**ADDENDUM NO. 7**

**CONTRACT NO. 20-517**

**REHABILITATION OF GLEN ISLAND APPROACH BRIDGE  
OVER NEW ROCHELLE HARBOR (BIN 3348880)  
NEW ROCHELLE, NEW YORK**

CONTRACT NUMBER: 20-517 SHEET NUMBER: S-02  
 SHEET NO. 43 OF 212  
 SCALE: AS SHOWN DATE: 03/08/2024  
 DPW FILE NO. 5-04-R-478-0 REV. NO. 3

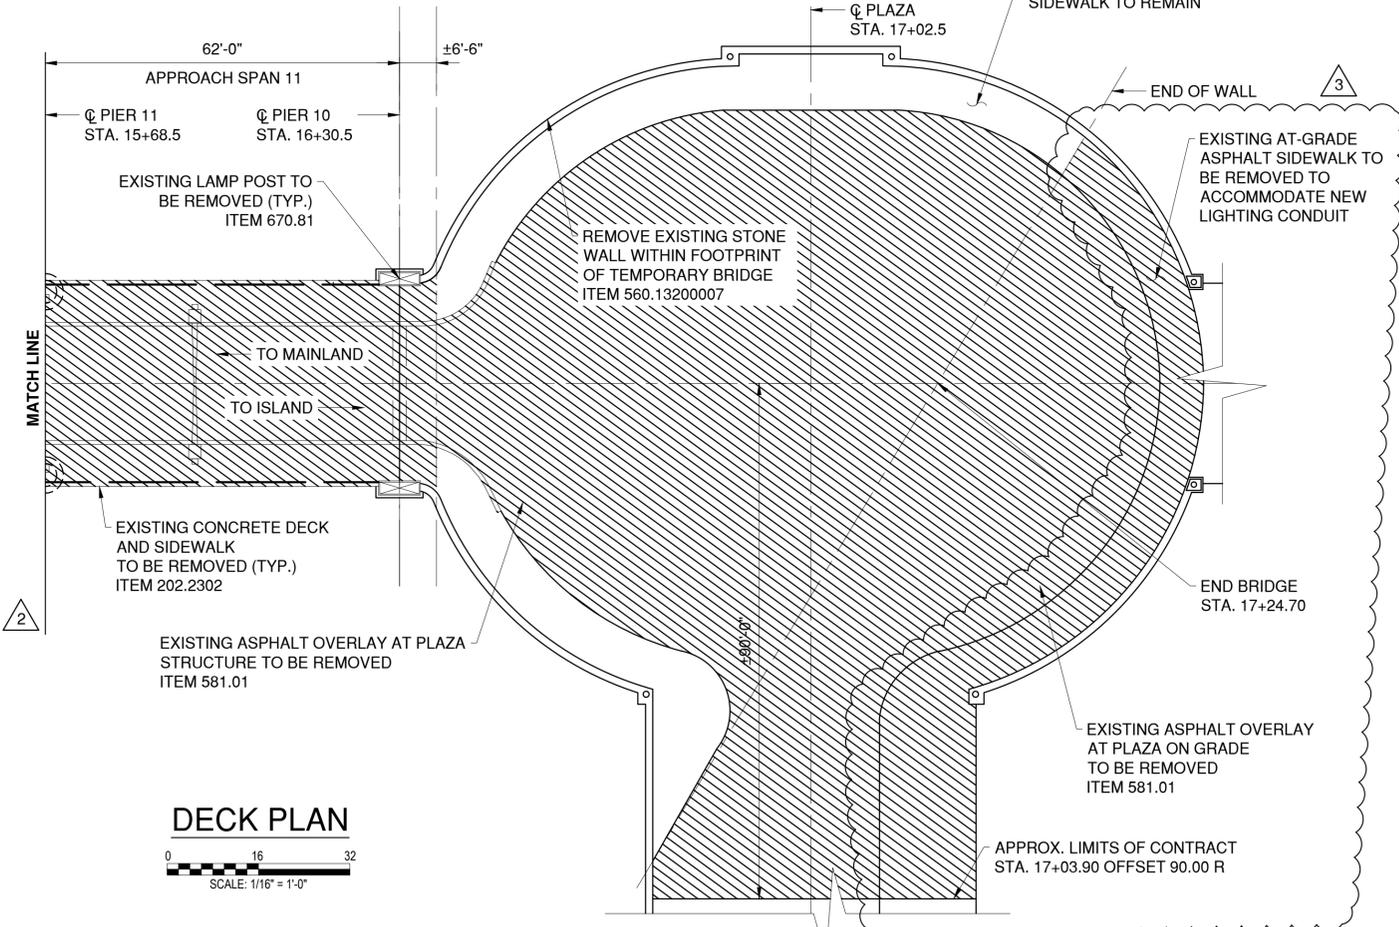
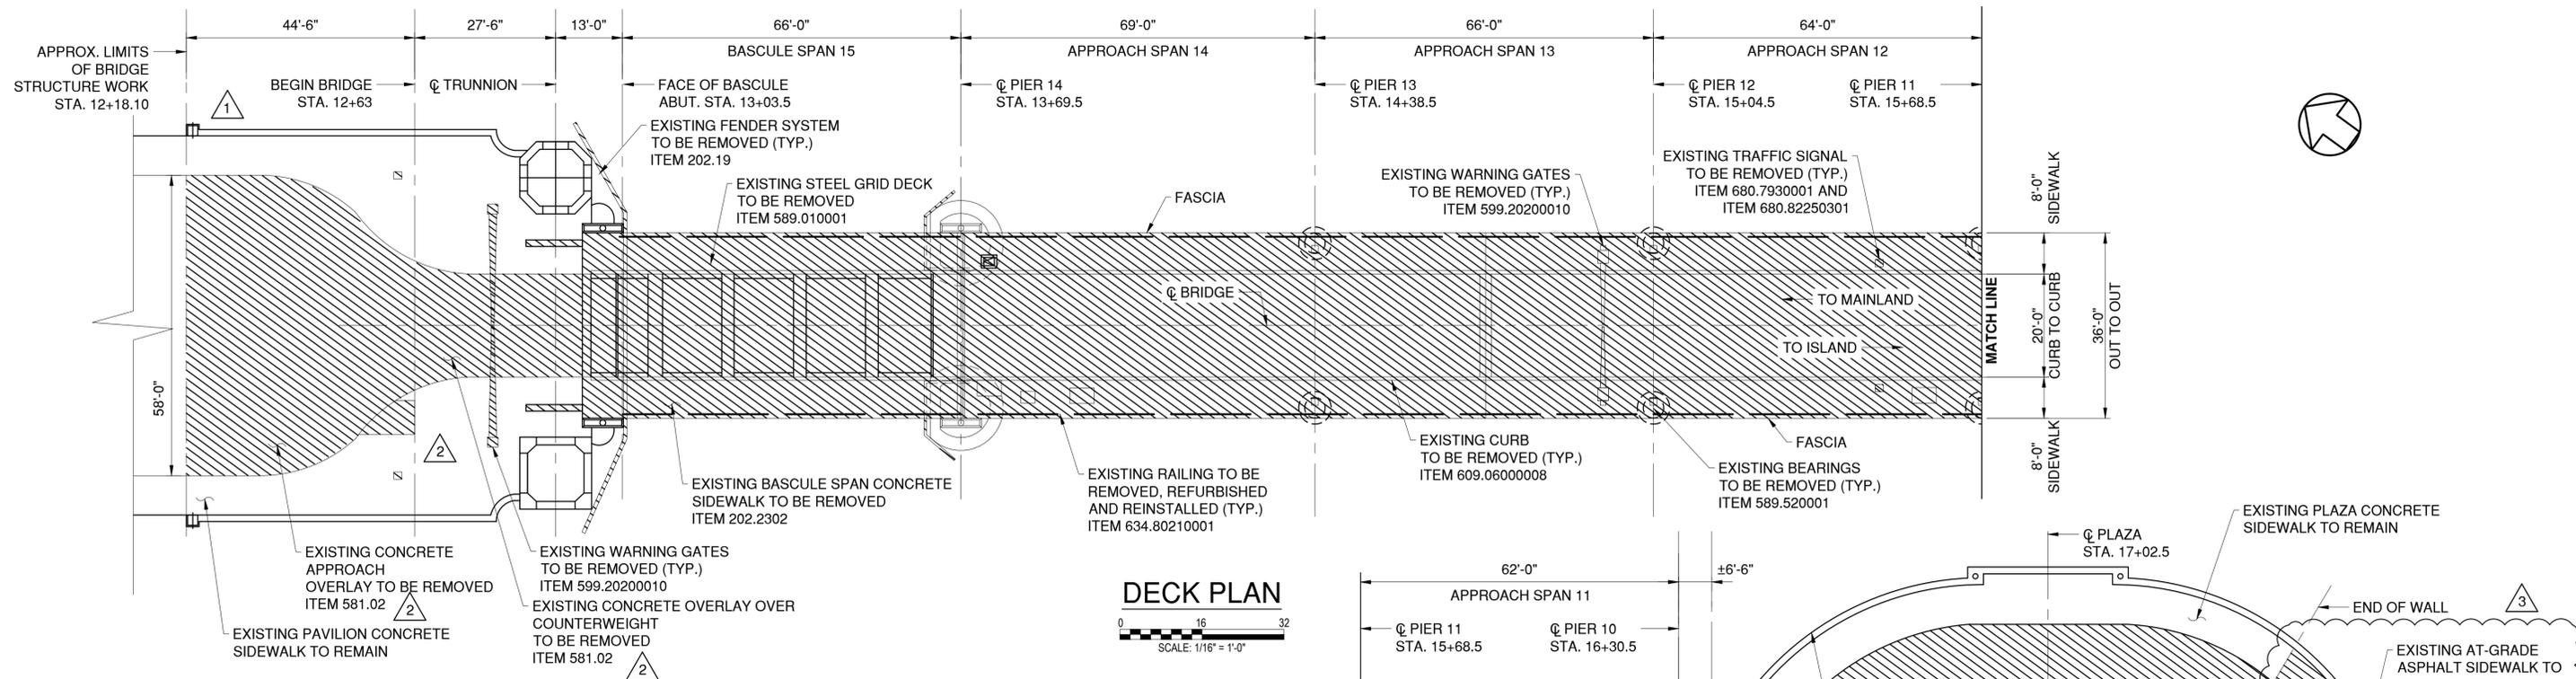
181	022	Mass Electric	Please clarify what does the existing Submarine Cable Terminal Cabinet on the far side provide power for?	The existing far side submarine cable provides power including but not limited to: far side navigation lighting, far side traffic gates, far side traffic signals, far side street lighting, far side advance warning lights, etc.
182	022	Mass Electric	On drawing E-39 shows the proposed roadway conduit layout. Please clarify if the sidewalk is to be removed and replaced for the installation of conduit and flush mounted terminal boxes.	The concrete sidewalk on the plaza shall remain and the conduit affixed to the underside of the slab shall be replaced. The at-grade asphalt sidewalk in the plaza area (south of the abutment wall) shall be removed such that the conduit can be replaced. New asphalt sidewalk shall be installed per GP-02. See revised sheet number S-02 included with Addendum #7.

CONTRACT NUMBER 20-517	SHEET NUMBER E-11
SHEET NO. 173 OF 212	
SCALE: AS SHOWN	
DATE: 03/08/2024	
DPW FILE NO.	REV. NO.
5-04-E-608-0	1

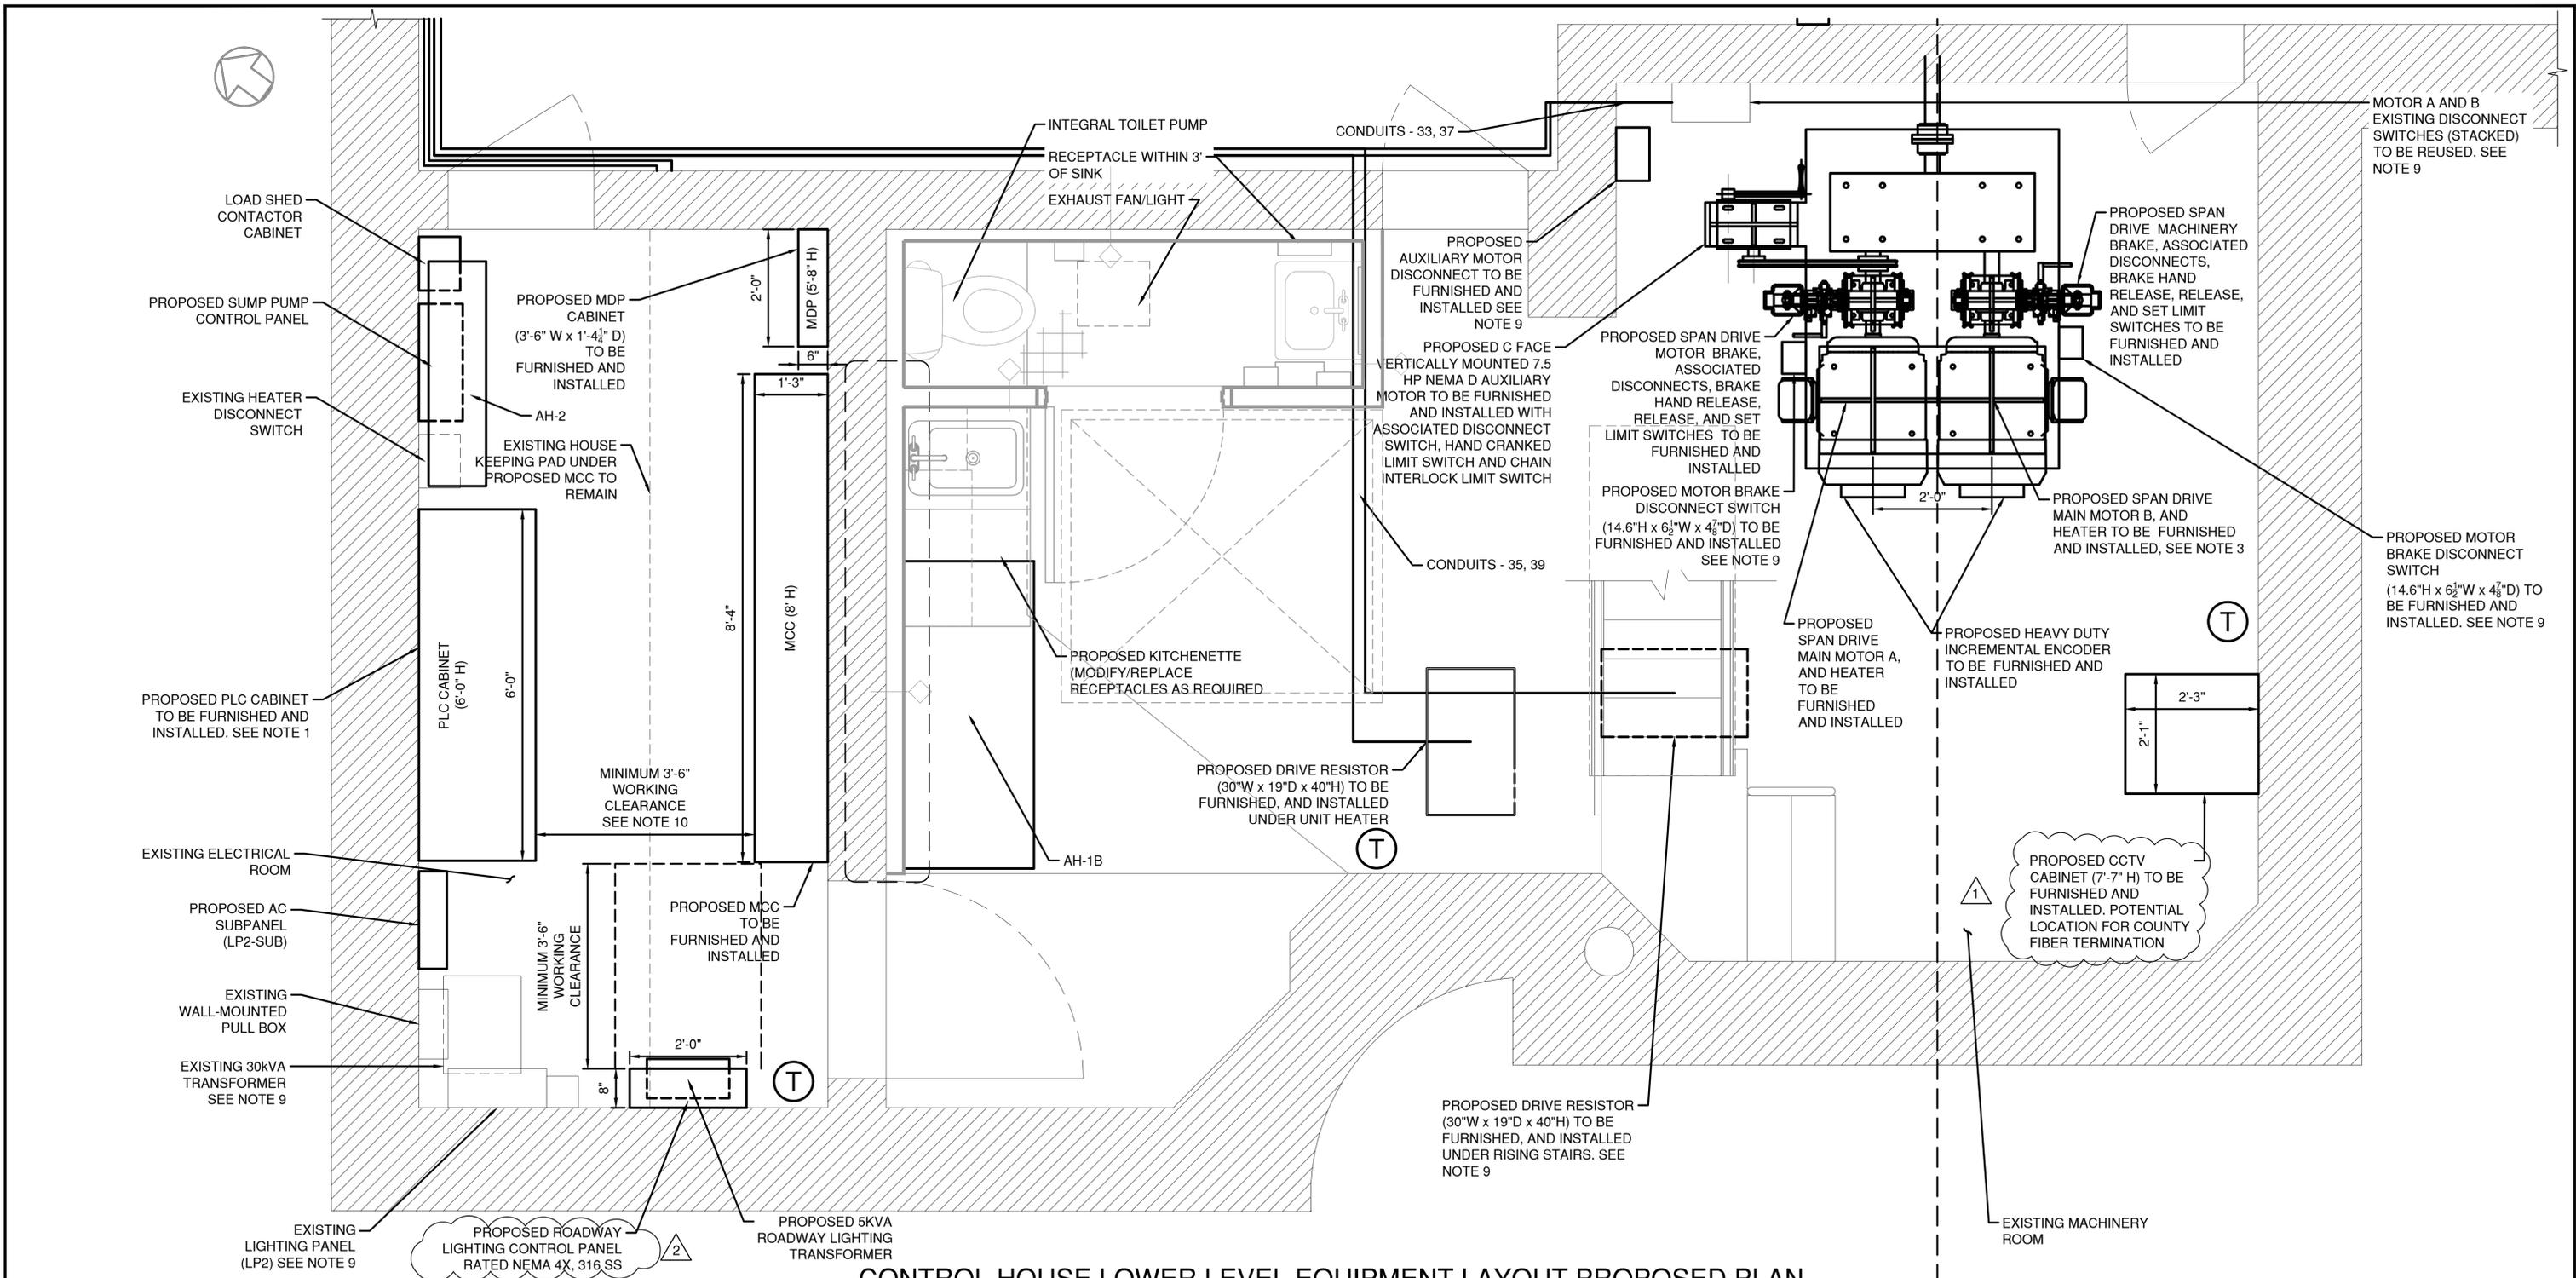
214	027	RCC	In reference to drawing E-34, please provide the location of the MOVABLE DCTC and FIXED DCTC.	The droops cable cabinets are shown on E-11 and are a direct replacement of the existing. They are across from the proposed drive cabinets. Contractor would need to reference the mandatory walk through for details on the existing setup as the plans call for a direct replacement.

Question #	RFI #	Contractor	Question	Response
215	027	RCC	In reference to drawing E-34, please provide a specification for the droop cable.	Note 2 on E-11 calls out the requirements for the droop. In summary, the droop cable shall be a Prysmian (Draka) Bridge Traveling (Droop) Cable to match the existing conductors. More information from Prysmian can be found here: <a href="https://na.prysmian.com/sites/na.prysmian.com/files/media/documents/SPL-BRG-0003-0213_Bridge%20Traveling%20%28Droop%29%20Cable_LR.pdf">https://na.prysmian.com/sites/na.prysmian.com/files/media/documents/SPL-BRG-0003-0213_Bridge%20Traveling%20%28Droop%29%20Cable_LR.pdf</a>
